Seechcraft SERVICE INSTRUCTIONS

No. 0683-394, Rev. I ATA Code 34-10

INSTRUMENTS - PITOT AND STATIC SYSTEM - INSTALLATION OF OPTIONAL

EMERGENCY STATIC AIR VALVE

Figure 1

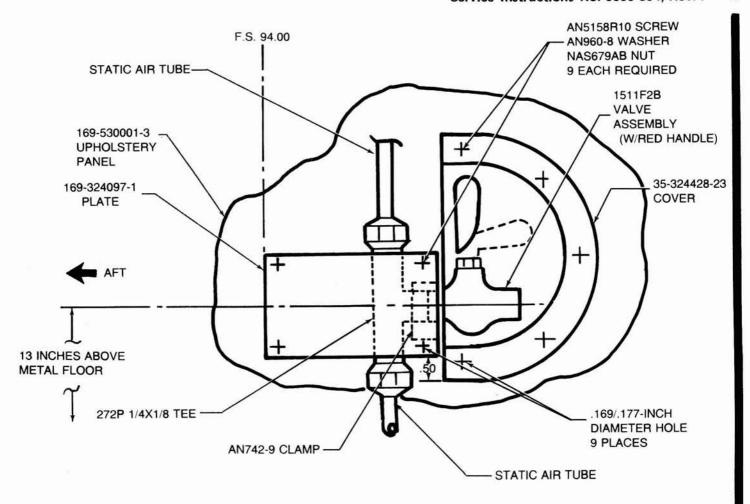
ACCOMPLISHMENT INSTRUCTIONS are simplified and revised parts are added to the kit.

- 1. Locate fuselage station (F.S.) 94.00 on the left side of the cabin interior (see figure 1).
- 2. Place the 169-324097-1 plate so that it is centered horizontally 13 inches above the metal floor and the aft edge of the plate is at F.S. 94.00. Use the 169-324097-1 plate for a template and drill four .169/.177 inch diameter holes through the 169-530001-3 upholstery panel (see figure 1).

should be .50 inch below the bottom edge of the 169-324097-1 plate (see figure 1).

- 6. Remove the 169-530001-3 upholstery panel and install the 169-324097-1 plate and the 35-324428-23 cover on the 169-530001-3 upholstery panel using AN515-8R10 screws, AN960-8 washers and NAS679A8 nuts (see figure 1)
- 7. Determine the best location at which to cut the 169-

580001-13 static air tube by putting the 169-530001-3 upholstery panel in place and marking the tube where it will fit into the 272P 1/4X1/8 tee (see figure 1).Remove the 169-530001-3 upholstery panel and cut the static air tube.

- 8. Install the 272P 1/4X1/8 tee on the 169-580001-13 static air tube per figure 1. This tee is manufactured with two fittings to connect to the 169-580001-13 static air tube and one fitting to connect to the 1511F2B valve assembly.
- 9. Install the 1511F2B valve assembly on the 272P 1/4X1/8 tee per figure 1.
- 10. Reinstall the 169-530001-3 upholstery panel. Attach the 1511F2B valve assembly and the 272P 1/4X1/8 tee to the 169-530001-3 upholstery panel using the AN742-9 clamp (see figure 1)
- 11. Test the static system for leaks in accordance with Federal Aviation Regulations.

Figure 2

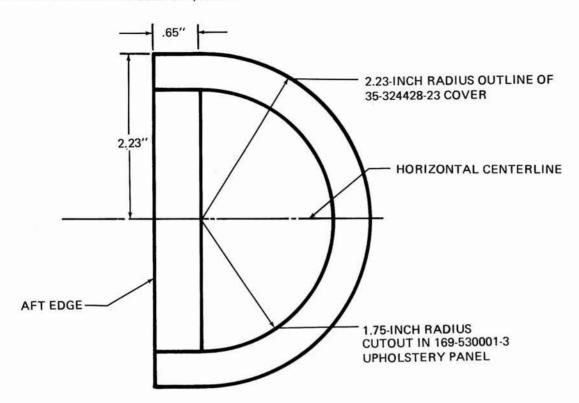
- 4. The cutout in the upholstery panel may be accomplished as follows: (Refer to figure 2 for steps 4a through 4e.)
- Using thin aluminum (obtain locally), make a template by drawing the outline of the 35-324428-23 cover.
- b. Locate and mark the horizontal centerline on the template.
- Mark a vertical line .65 inch forward of the aft edge of the template.
- d. Mark a 1.75 inch radius from the intersection of the horizontal centerline and the line drawn in step "c".
 - e. Cut the template out as shown in figure 2.
- f. Using this template, mark the cutout in the 169-530001-3 upholstery panel and cut out the marked portion of the panel.
